**EVALUATION OF REAL SCIENTIFIC DATA
ABOUT NEW CRS AVAILABLE ON THE
MARKET SO CALLED “BELT GUIDE”
VS OTHER APPROVED CRS’**

Geneva 10-13 December

Informal Document GRSP-66-19

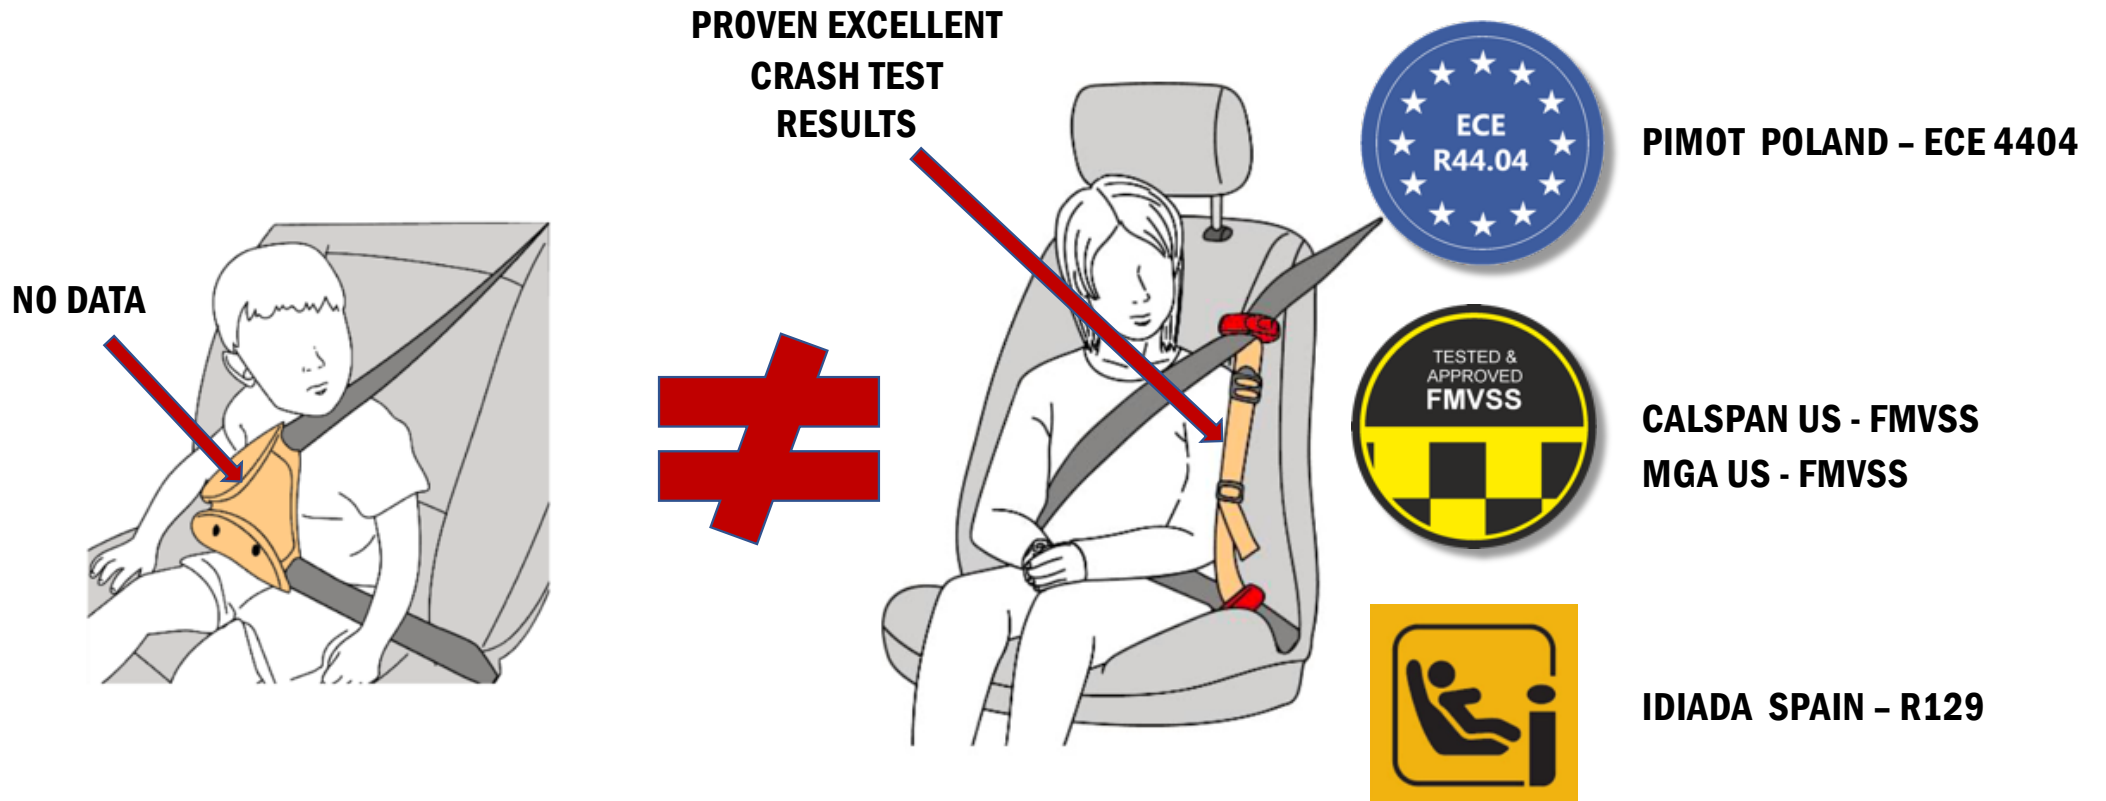
Insert a new paragraph 1.2., to read:

"1.2. This Regulation explicitly forbids child restraint systems in the form of belt guides and other sitting devices that are dangerous and can harm children in the event of a vehicle collision, **irrespective of any test results obtained in accordance with paragraph 8.**

In particular, it concerns belt guides and sitting devices meant for children of a mass from 15 kg to 36 kg that connect to or attach onto the lap belt portion as well as the torso belt portion of a 3-point adult safety belt system with the aim to alter the adult safety belt routing by for example pulling down the torso belt portion or squeezing together the torso belt portion and lap belt portion. Examples of such non-compliant devices are shown below.

It also concerns sitting devices that are unusable by a child unless they are properly inflated or other compact sitting devices that attempt to guide the lap belt portion by keeping it down or forward, just above the seat cushion, rather than to significantly elevate the child in relation to the vehicle's normal seating position and the corresponding adult safety belt effective lower anchorages."

Graph 2. Decelerations of the chest for 15 kg dummy during dynamic test

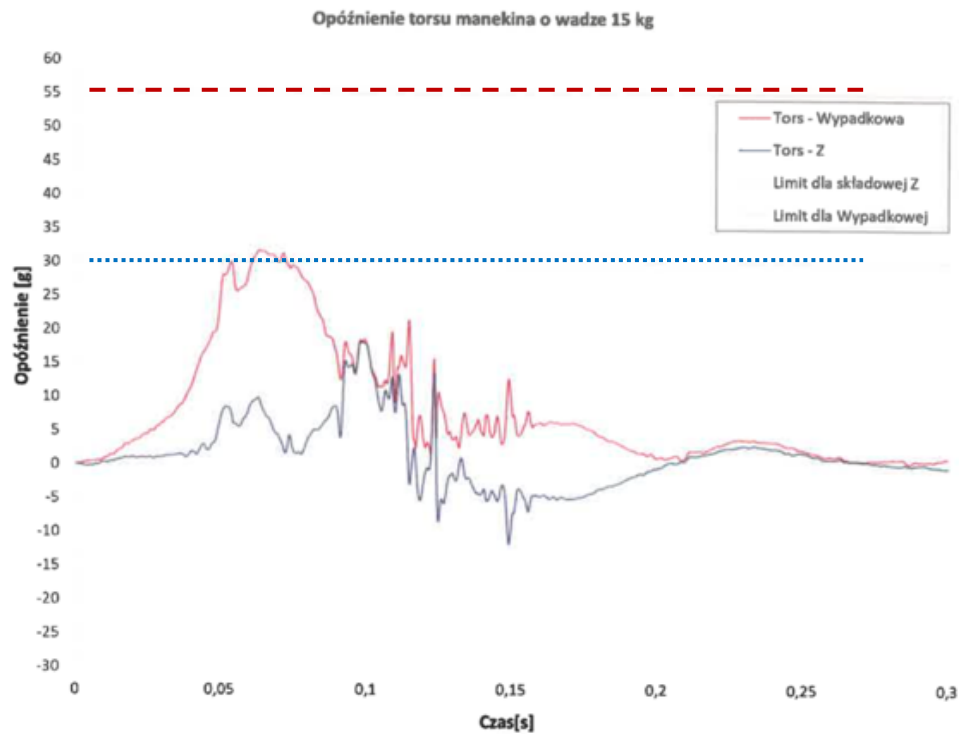
SMART KID BELT – 15 kg dummy

Chest Resultant Deceleration – **31,67G**

Graph 1. Decelerations in the dummy 15 kg chest during dynamic test

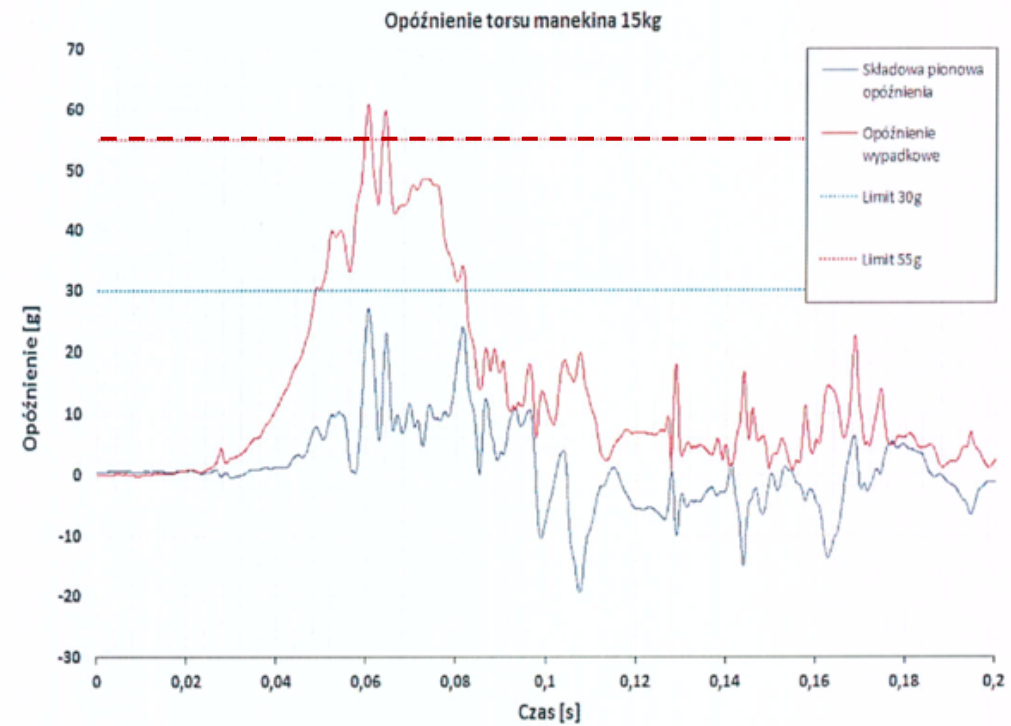
CHILD CAR SEAT – 15 kg dummy

Chest Resultant Deceleration – **60,94 G** / during 2,6 ms

Graph 3. Decelerations of the chest for 22 kg dummy during dynamic test

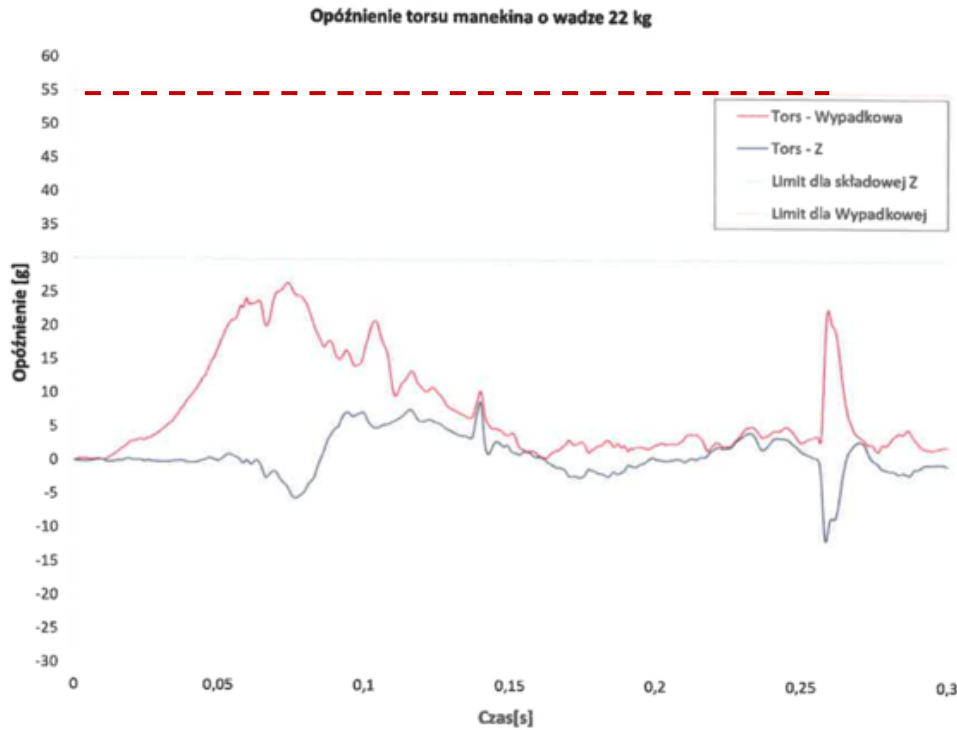
SMART KID BELT - 22kg dummy

Chest Resultant Deceleration - **26,47G**

Graph 3. Decelerations of the chest for 32 kg dummy during dynamic test

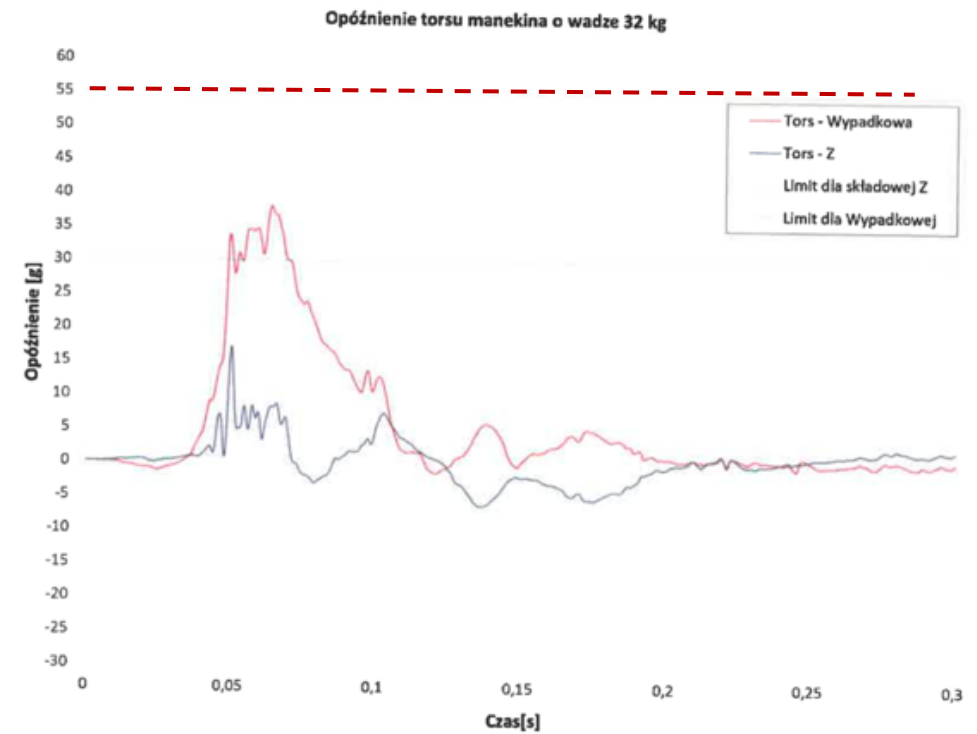
SMART KID BELT - 32 kg dummy

Chest Resultant Deceleration - **38,03 G**

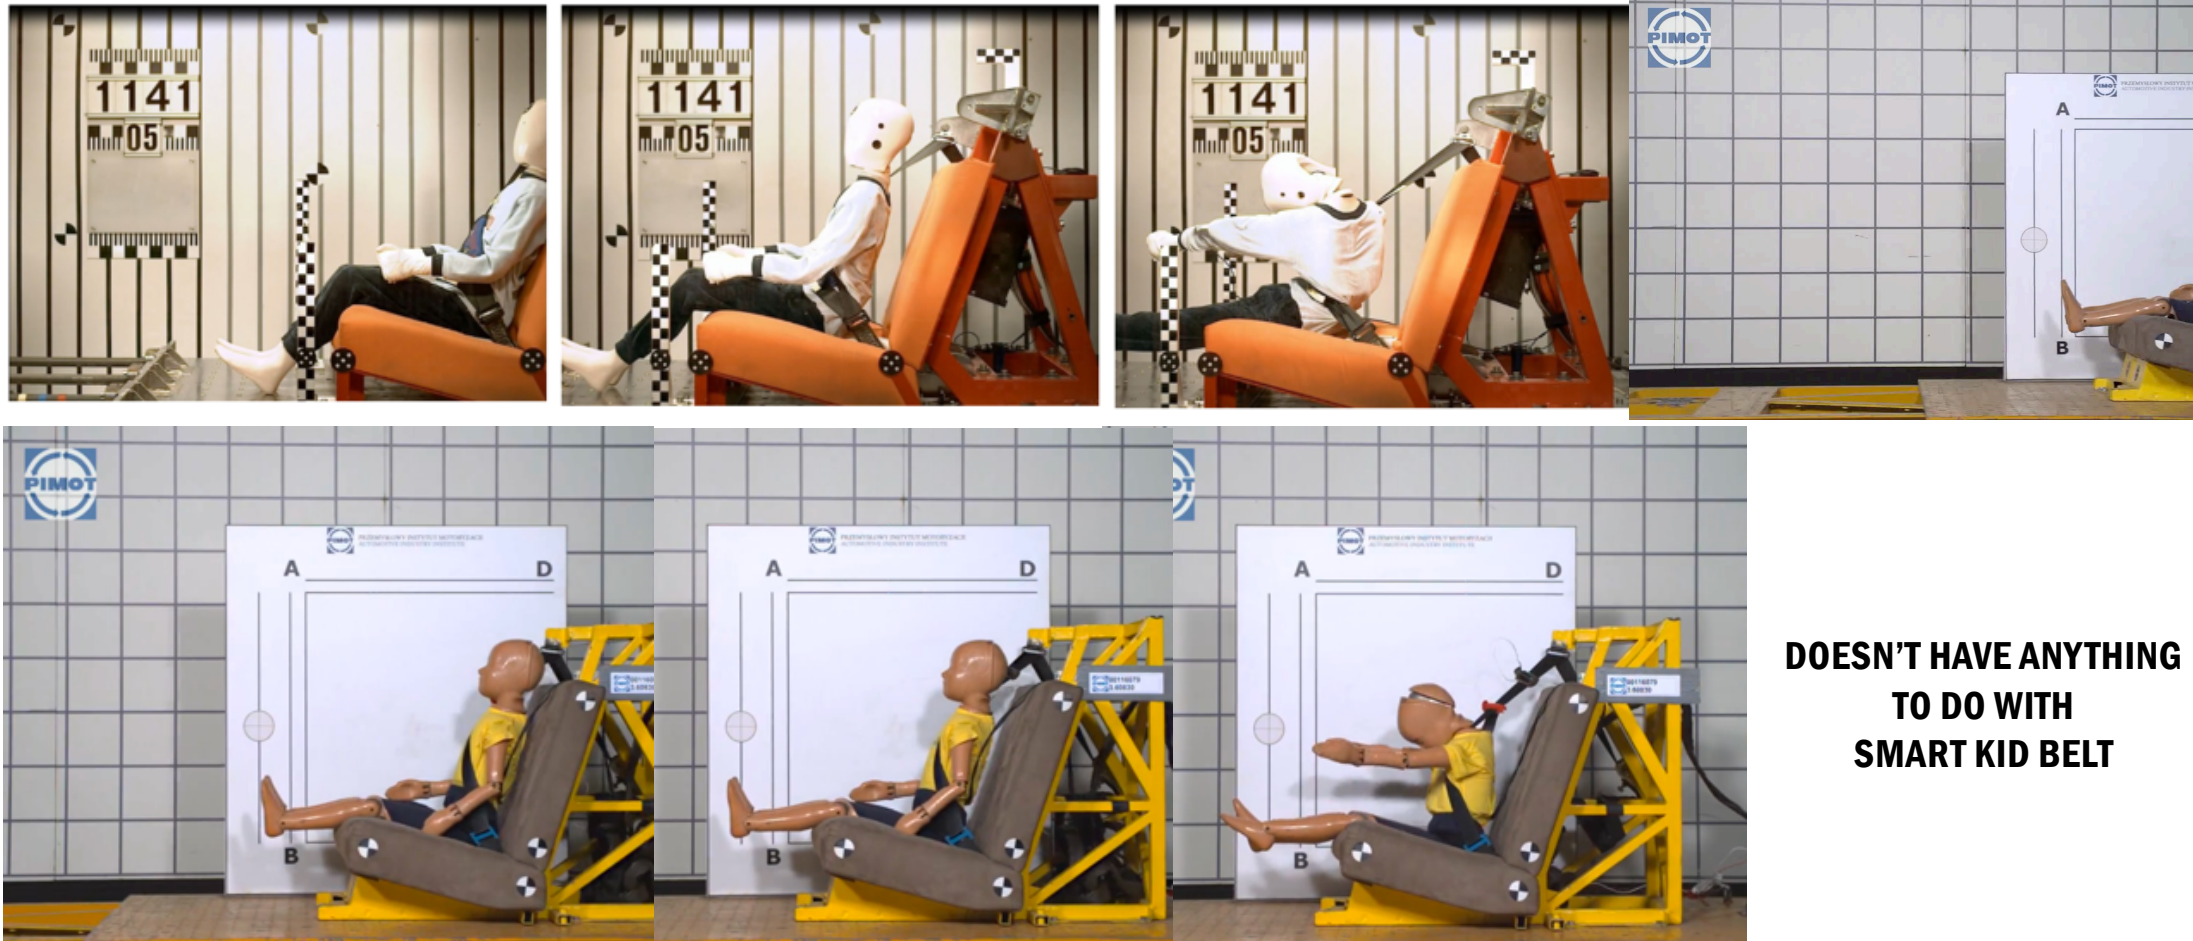
Figure 1a: Time 0 ms - Initial Q6 dummy position

Figure 1b: Time +50 ms – Q6 dummy and belt geometry during loading phase
No submerging observed

Figure 1c: Time +100 ms –normal belt geometry during max loading
No submerging observed

With reference to document GRSP-50-09e & GRSP-50-25e – **SUBMERGING**

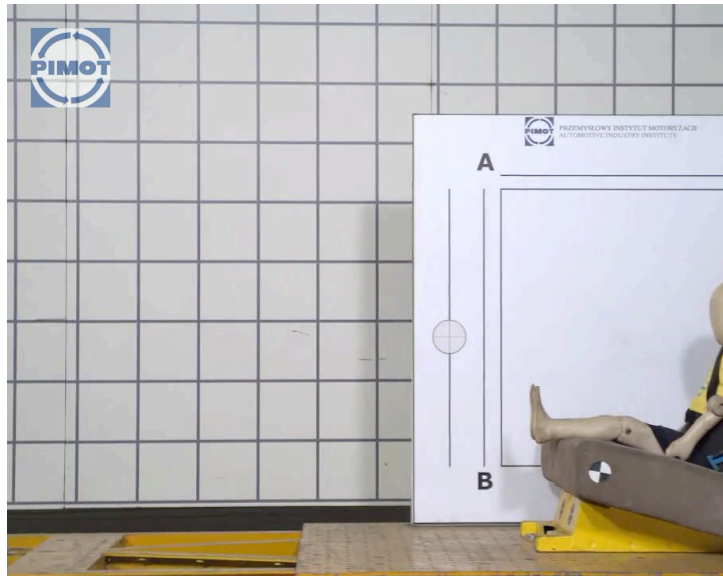
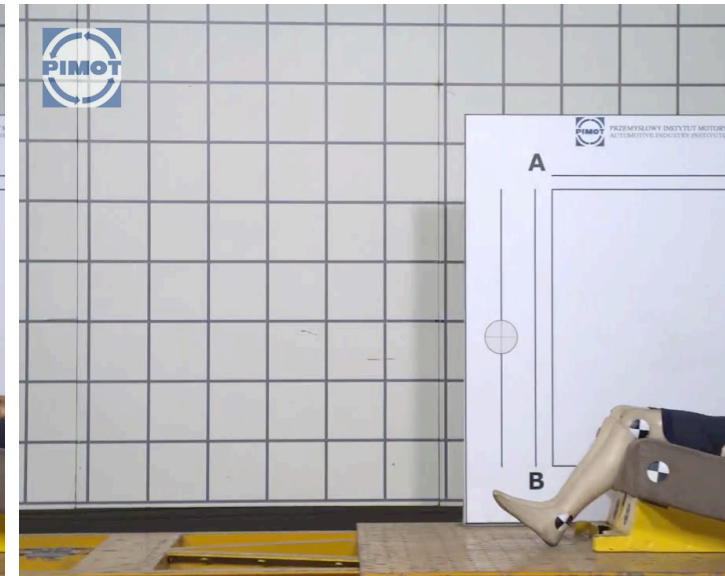
**DOESN'T HAVE ANYTHING
TO DO WITH
SMART KID BELT**

TEST +

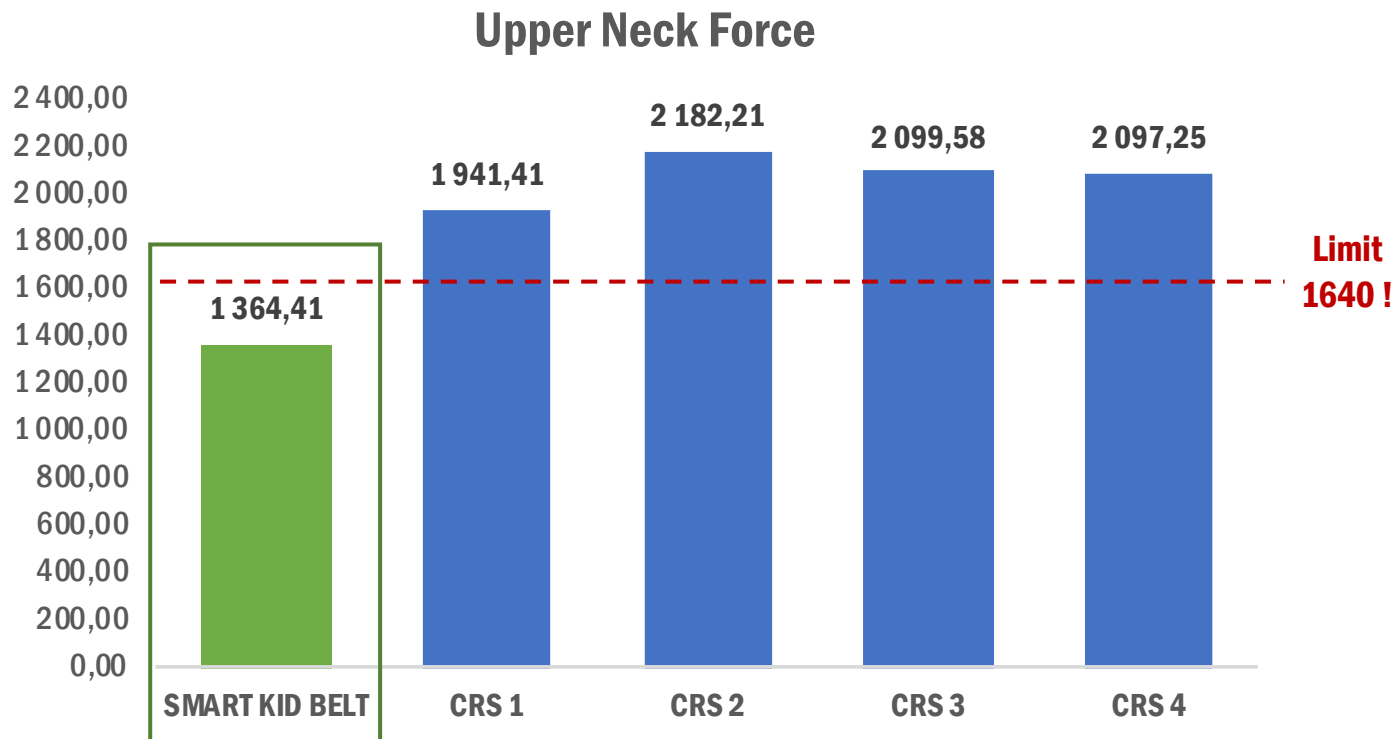
Our Scandinavian colleagues were so delighted with the results of “TEST +” but in particular with one parameter “UPPER NECK FORCE” and for group II & III they set the limit at 1640 N
